CENTERVILLE CITY PLANNING COMMISSION AGENDA

PLANNING COMMISSION MINUTES OF MEETING

BACKGROUND

The applicants desire to receive final site plan approval for the Legacy Trail Apartments Development project. The project consists of four (4) lots; three (3) commercial and one (1) multi-family residential. Additionally, and due to the fact that the project has not yet recorded a subdivision plat, the applicants seek from the Planning Commission an allowance to develop the individual lots in phases (*Section 12-21-110.f*). Phases 1-3 would be developed as separate individual lots with each lot required to obtain a separate final site plan approval. Phase 4, the residential uses, would be reviewed and approved as part of this final site plan request before the Planning Commission.

OVERALL SITE AREA	366,723 S.F.
LANDSCAPE AREA	134,394 S.F. = 36.6%
TREES PROVIDED	90 TREES - 1 TREES / 1,473 S.F.

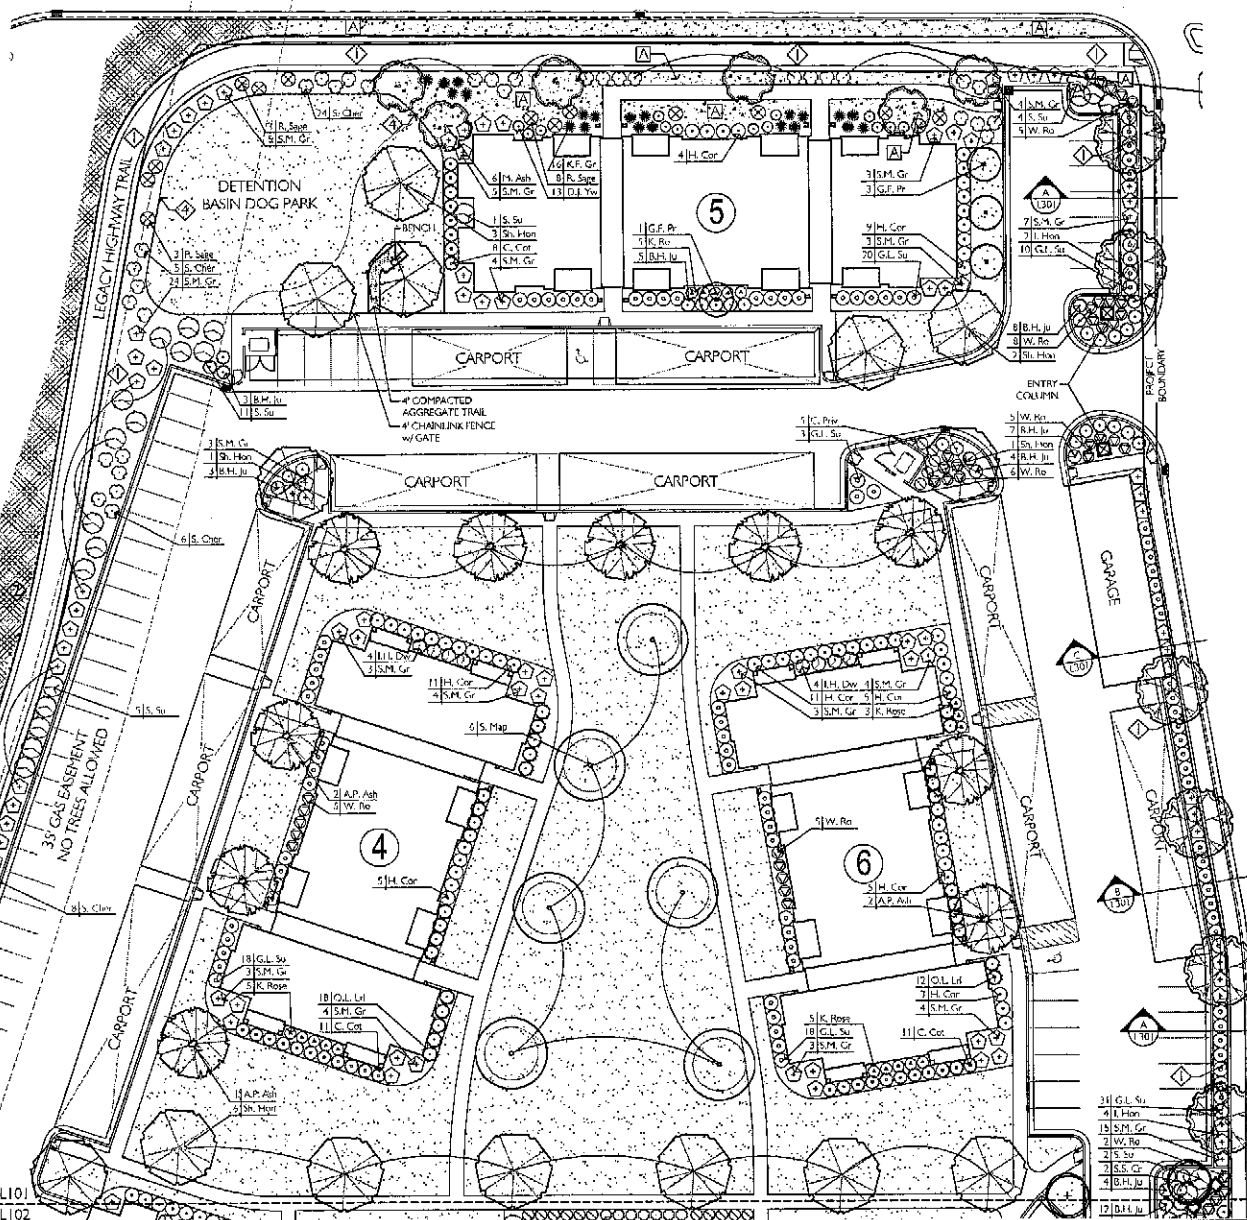
Staff Comment: 162 trees are required, only 90 provided. A waiver is needed to reduce the total number of trees to 113 trees (*missing 23 trees*).

Staff Comment: The submitted plans comply with landscaping depth and foundation plantings. However, the plans only provided seven (7) of the required 10 trees.

6. The Landscaping Plan shall be revised, as follows:
 - i. Revised to provide the required 162 landscaping trees. Nonetheless, the applicants may make application and seek a "waiver of strict compliance" to be reviewed and considered by the Planning Commission

- ii. Revised to provide 10 streetscape trees along Parrish Lane
 - iii. Revised to provided one tree and two (2) shrubs for every 25 sq. ft. of required internal parking landscaping (5% is required)

Sheet Title
Architectural
Site Plan

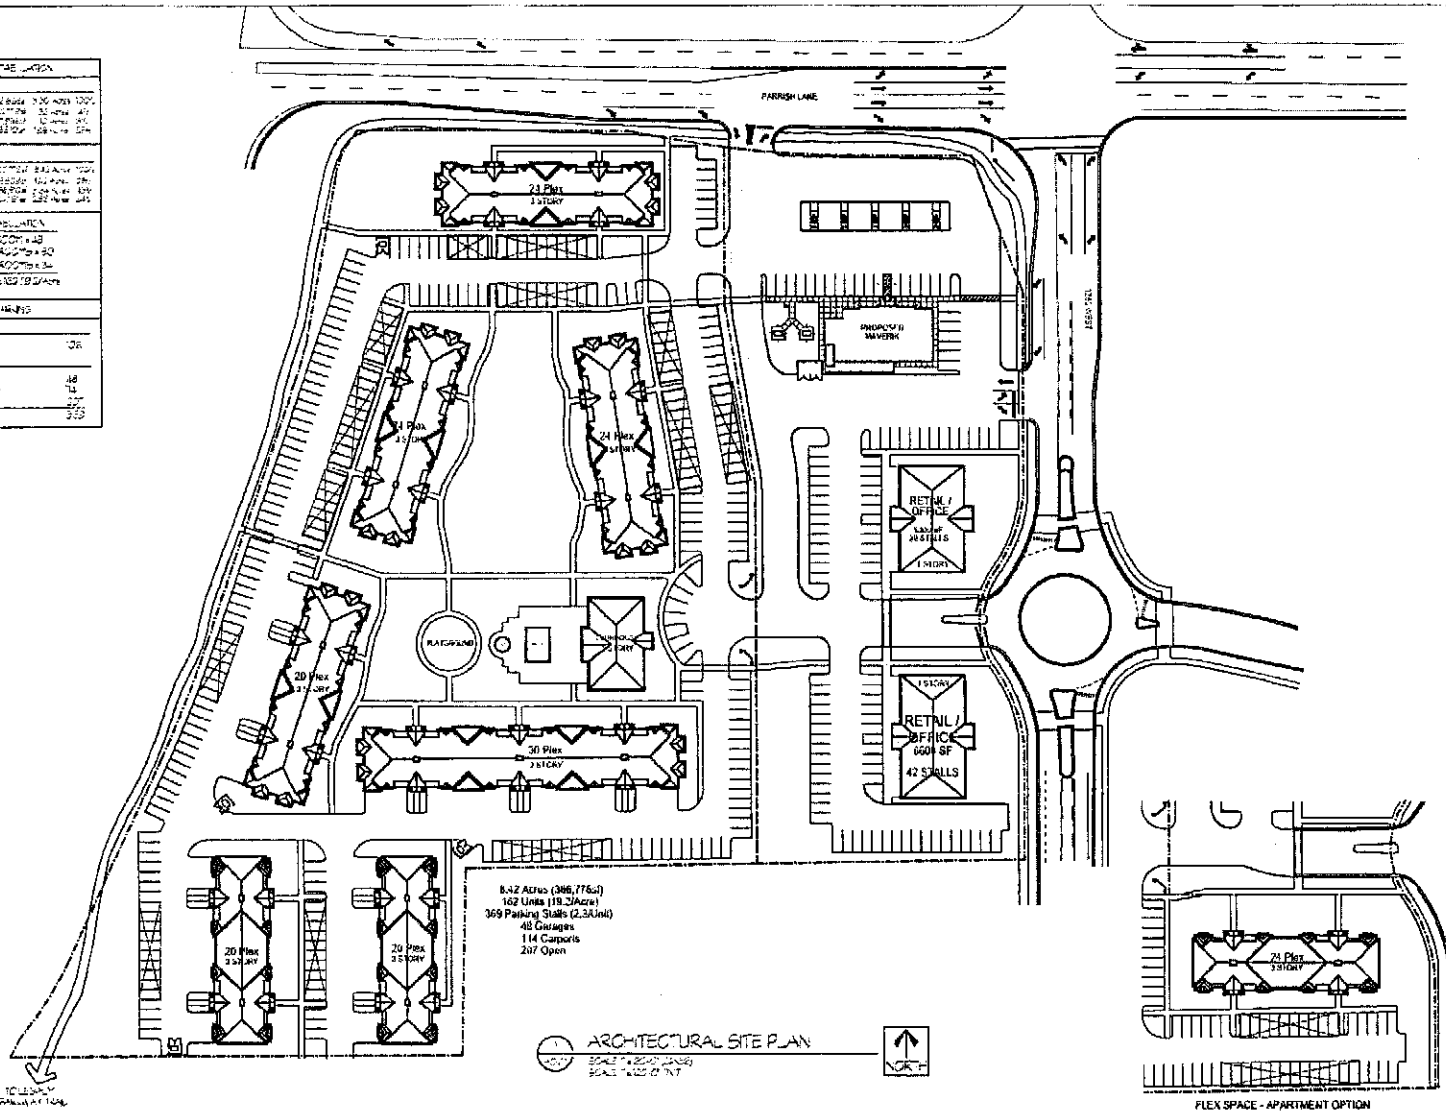
Staff Comment: *Submitted plans generally appear to comply with PDO expectations. However, the submitted plans neglect the visual design and treatment of the accessory buildings, such as the detached garages, carports, clubhouse, and dumpster facilities.*

Staff Comment: Submitted plans *do not address the design and materials of the expected fencing plan. Additionally, the design guidelines require the use of periodic interval pillars for visual relief.*

- ✦ **Screening of Utility and Mechanical Equipment & Lighting** – **Not Provided/Incomplete**
Staff Comment: The submitted plans *neglect to address the screening of utility equipment and meters, as well as the use of satellite dishes. Nonetheless, any wall-based or ground equipment needs to be screened from view of the public street, either through man-made elements or by plant materials as part of the landscape design. Additionally, the submitted plans do not address the use of lighting for security and safety.* Lighting fixtures are to compliment the architectural theme of the “village style” design.

Staff Comment: The submitted plans appear to provide the required on-site parking and access requirements. Additionally, the plans need to address the compliance with applicable ADA Regulations.

Staff Comment: The submitted plans appear to provide the required amount; 162 dwelling units equals 324 parking spaces. The plans depict 279 parking spaces, plus 50 tandem spaces (to be approved by Planning Commission), which equals 329 total parking spaces. The plans appear to meet minimum sizes, with the exception that the plans lack width and door dimensions of the garages.

Staff Comment: A Lighting Plan was not provided.

- i. *Resubmitted plans shall address the visual design and treatment of the accessory buildings, such as the detached garages, carports, clubhouse, and dumpster facilities. The design and treatment shall be compatible with the design and treatment of the main buildings.*

- ii. *Resubmitted plans shall address the design and materials of the expected fencing plan. Additionally, the fencing shall address the Design Guidelines requiring the use of periodic interval pillars for visual relief.*

- iii. *Resubmitted plans shall address the screening of utility equipment and meters, as well as the use of satellite dishes. Any wall-based or ground equipment shall be screened from view of the public street, either through man-made elements or by plant materials as part of the landscape design.*

- iv. *The resubmitted plans address the use of lighting for security and safety. Lighting fixtures are to compliment the architectural theme of the "village style" design and shall comply with the outdoor lighting standards of the Zoning Ordinance or other applicable City Regulation.*

- v. *The final site plan submittal shall address the compliance with applicable ADA Regulations for parking and access to the buildings within the development.*
